# UNITED STATES PATENT AND TRADEMARK OFFICE

APPLICATION NO.	FILING DATE	FIRST NAMED INVENTOR	ATTORNEY DOCKET NO.	CONFIRMATION NO.
10/536,479	10/03/2005	Michael R Treat	COL221-227791(A)	6897

<b>Office Action Summary</b>	<b>Application No.</b>	<b>Applicant(s)</b>	
	10/536,479	TREAT, MICHAEL R	
	<b>Examiner</b>	<b>Art Unit</b>	
	Derek J. Rosenau	2834

## **DETAILED ACTION**

Figure A

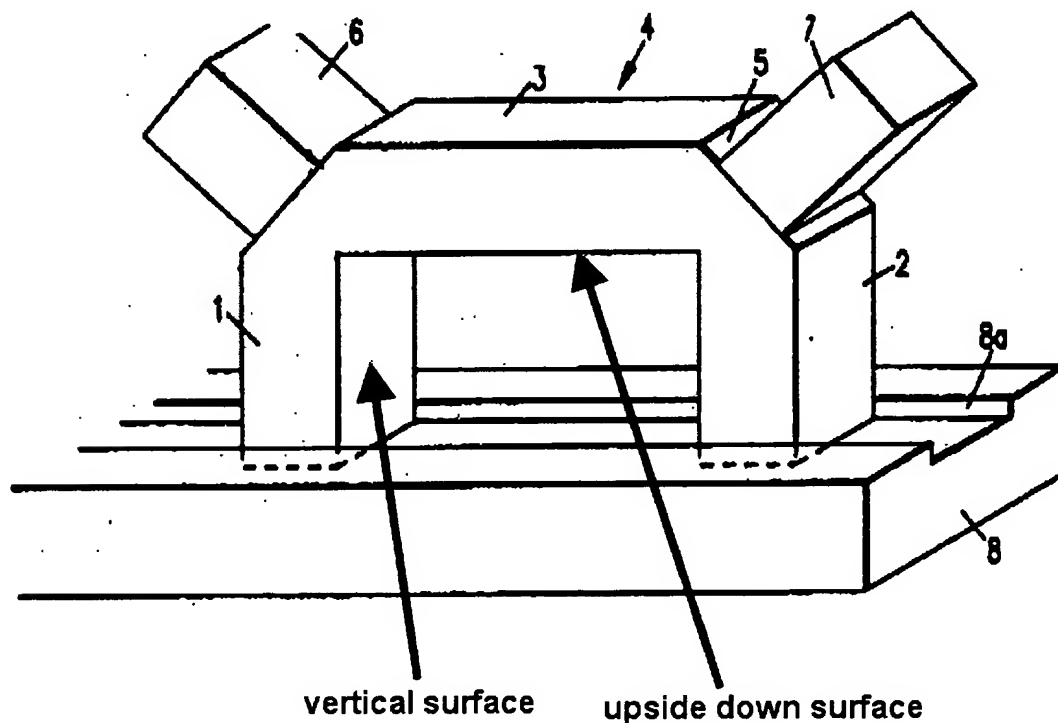
15. With respect to claim 6, Onishi et al. discloses the device of claim 5, wherein the surface (see Figure A below) is vertical.

16. With respect to claim 7, Onishi et al. discloses the device of claim 5, wherein the surface (see Figure A below) is upside down.

22. With respect to claim 13, Onishi et al. discloses the device of claim 12, wherein the surface (see Figure A above) is vertical.

23. With respect to claim 14, Onishi et al. discloses the device of claim 12, wherein the surface (see Figure A above) is upside down.
